ADDENDUM NO. 01
TO
SPECIFICATIONS AND CONTRACT DOCUMENTS FOR
INVITATION TO BID
BIMT BERTH 20 WHARF EXPANSION
JPA CONTRACT NO. ITB C-1814

"REVISED" BID FORM
JAXPORT PROJECT NO.: B2022-10
JAXPORT CONTRACT NO.: C-1814
BIMT BERTH 20 WHARF EXPANSION
BLOUNT ISLAND MARINE TERMINAL

BERTH 20 WHARF EXPANSION
DUAL COUNTY, FLORIDA

S-7
SHEET 15 OF 50

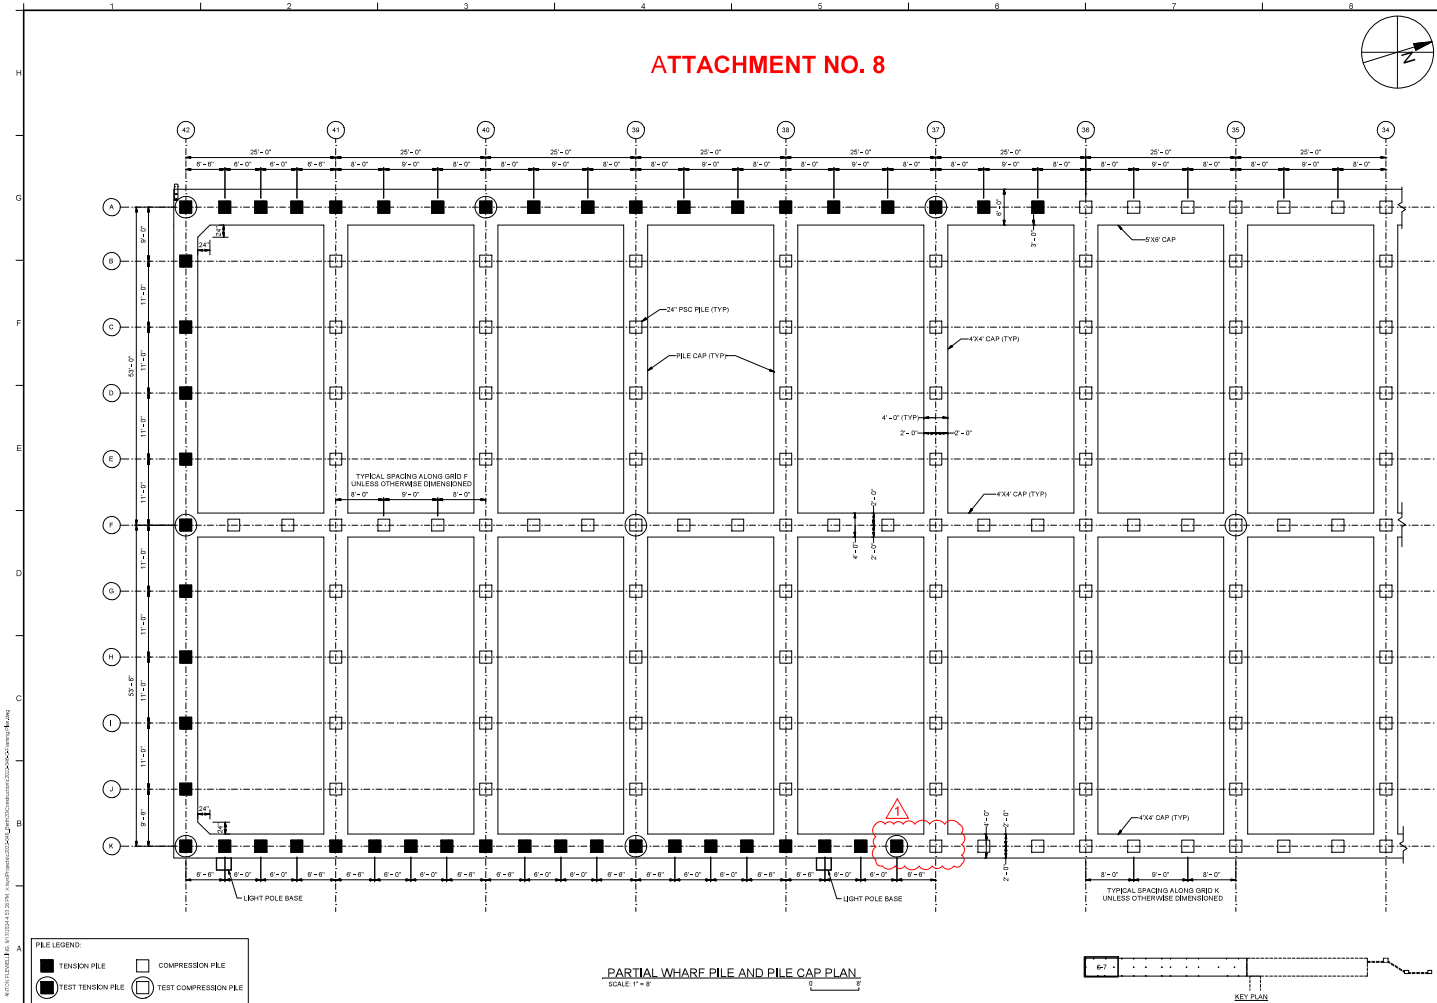
21. Reference Drawings S-2 / S-7: There is a discrepancy in quantity of pile types due to the pile at K-37 and 6'-6" south of K-37, being shown differently between Sheets S-2 and S-7. Please advise which is correct and confirm the quantities given on the pile schedule on sheet S-2.

ANSWER: Sheet S-2 is correct; the pile quantities given on the pile schedule on Sheet S-2 are confirmed as correct. Sheet S-7 incorrectly shows Pile K-37 as compression test pile. Sheet S-7 also neglected to show the pile immediately south of K-37 as a tension test pile. Sheet S-7 is corrected and attached to this addendum. See Attachment No. 8.

S-9

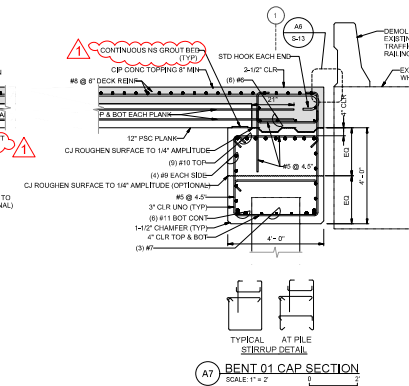
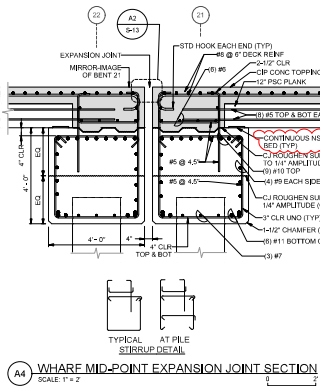
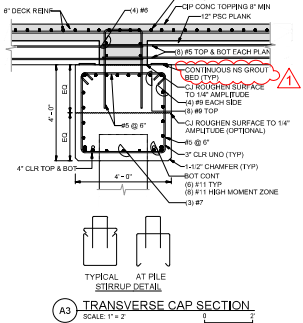
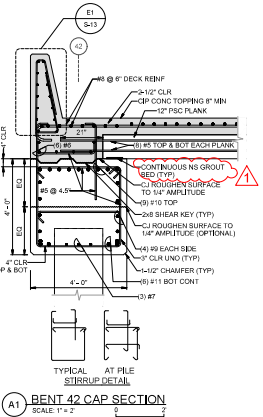
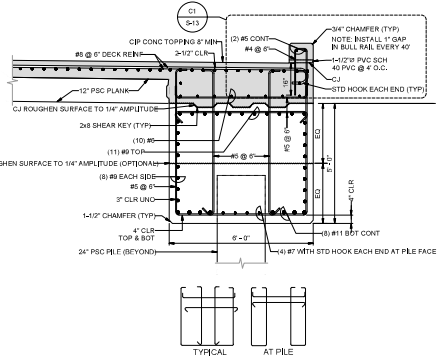
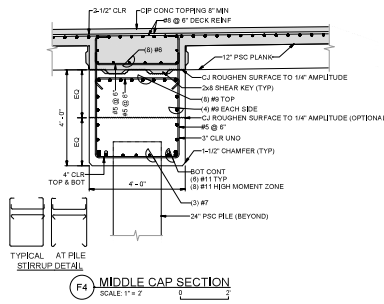
22. Reference Drawings S-9 / S-16: The continuous grout bearing pad is shown as 8" wide on Sheet S-9 and shown as 10.5" wide on Sheet S-16. Which is correct? Can the continuous grout and shim plates be replaced with neoprene or asphaltic bearing pads?

ANSWER: Sheet S-16 is correct with a 10.5-inch-wide continuous grout pad. Contractor's bid shall assume continuous grout pads poured around Korolath shims. Drawings are corrected and attached to this addendum. See Attachment No. 9.

12-IN BEARING DETAIL
NOT TO SCALE

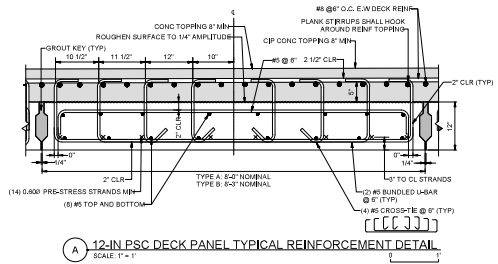
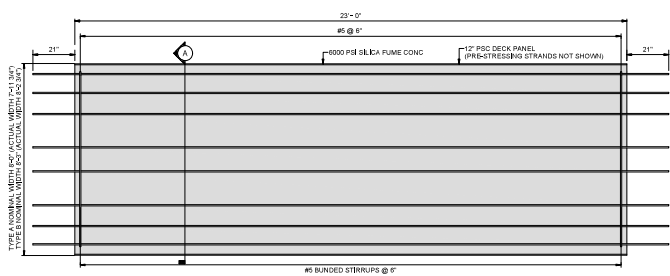
40. The Deck Panel design shown on Sheet S-16 and indicated in item 2 (Design of Prestressed Deck Panels) says to consider all plank reinforcement shown and detailed in the drawings as minimum reinforcement required. Following this basis for design, If the submitted design is inadequate will we be able to get a change order for our Specialty Engineer for additional design?

ANSWER: Deck slabs will be shimmed with Korolath bearing pads and a continuous grout bearing pad poured around and adjacent to shims. See "12-in Bearing Detail" on Sheet S-16. Drawings are corrected and attached to this addendum. See Attachment No. 10.

ANSWER: As indicated on Sheet S-16, the Specialty Engineer shall design and sign/seal deck panels. All costs for Specialty Engineer should be included in bid price.
